SCH-009 Alexandra Park, Hastings, Cycle scheme

East Sussex Highways

Combined Stage 1/2 Road Safety Audit

7th October 2019

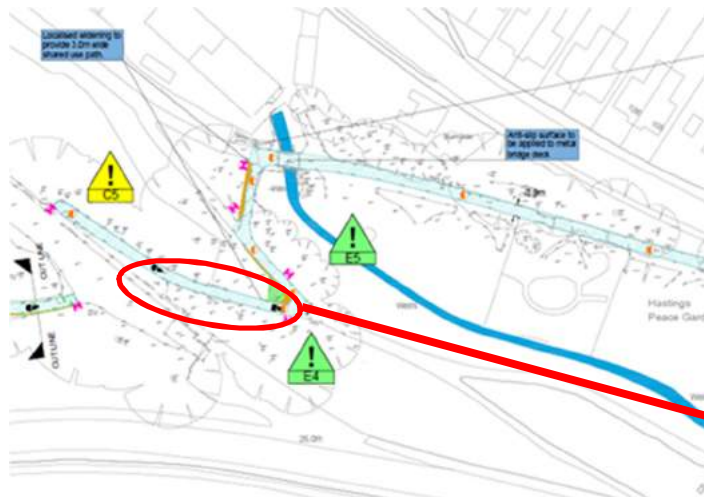
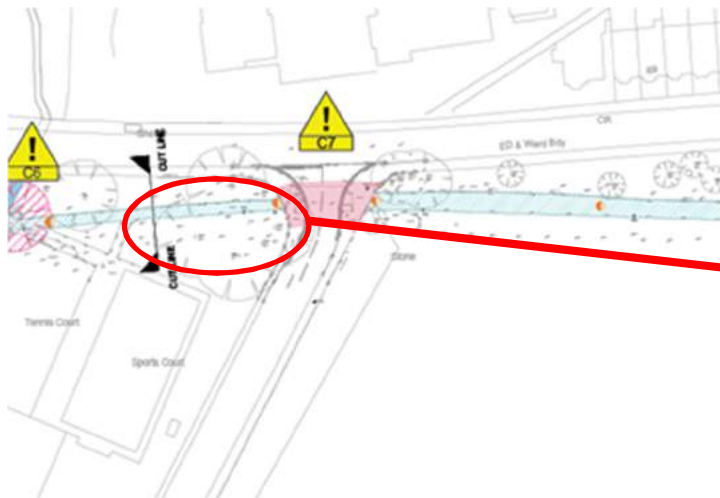
Within the lower park section, it was observed that there are existing changes in levels where the shared route and grass verges interface. If a cyclist's wheel left the shared route at these locations, the sudden change in level, often on a muddy surface, could lead to cyclists losing control increasing the risk of unseated riders and injuries.

It is recommended that level differences are removed using earthworks/top soiling along the length of the route.

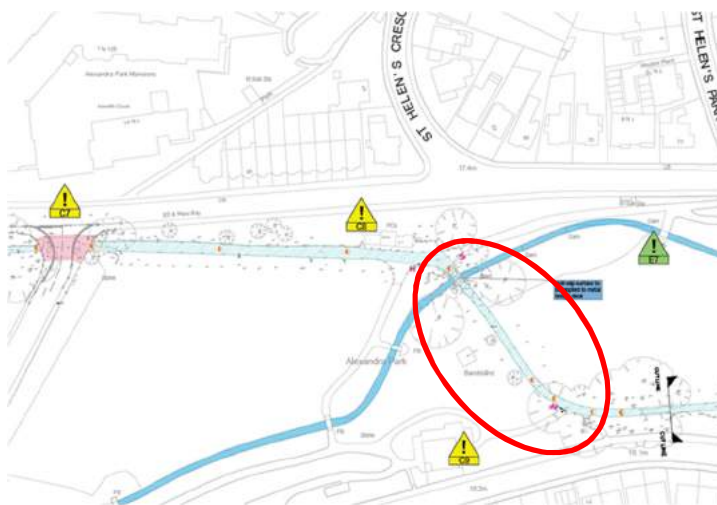
Some of the existing bridges are fitted with additional sections of extended parapet, which act as a physical barrier and guide to users, protecting them from steep drops into waterways. It was observed during the site visit that additional sections of extended parapet are omitted at other bridges along the route which could result in an increased risk of injury and severity should a cyclist leave the shared route.

A gap is also likely to be created at the stone bridge parapet when the proposed tree removal has been undertaken.

It is recommended that additional sections of extended parapet are provided at all bridges with adjacent gaps/steep drops into waterways.

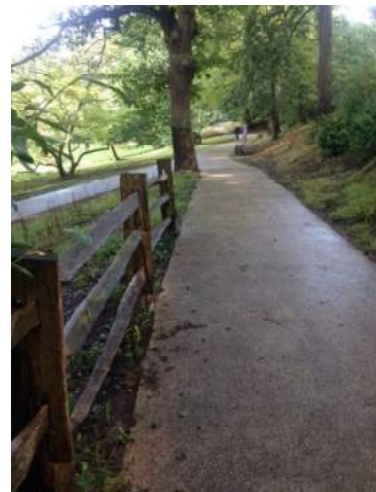
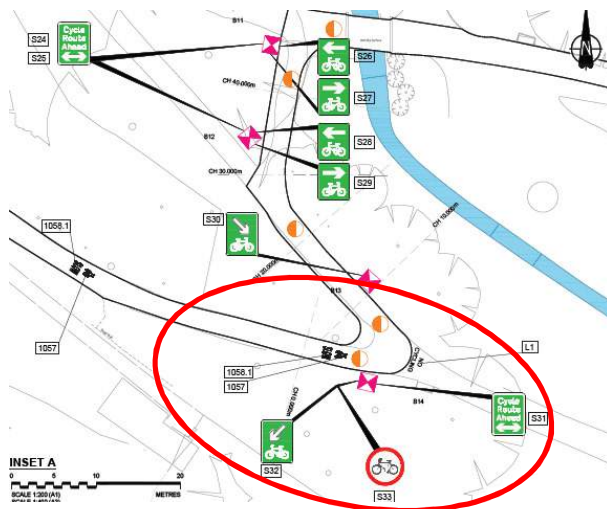
The shared route link between the upper and lower park crosses an ambiguous area with an unbound and poor quality surface subject to ponding. The area is used by vehicles, pedestrians and cyclists, but it is unclear who has priority. In addition, the proposed signing and markings do not provide clarity of the onward route. The combination of these problems could result in collisions between pedestrians, cyclists and vehicles.

It is recommended that a surface consistent with the rest of the shared route is provided along with signs and markings to address the route ambiguity and continuity concerns.
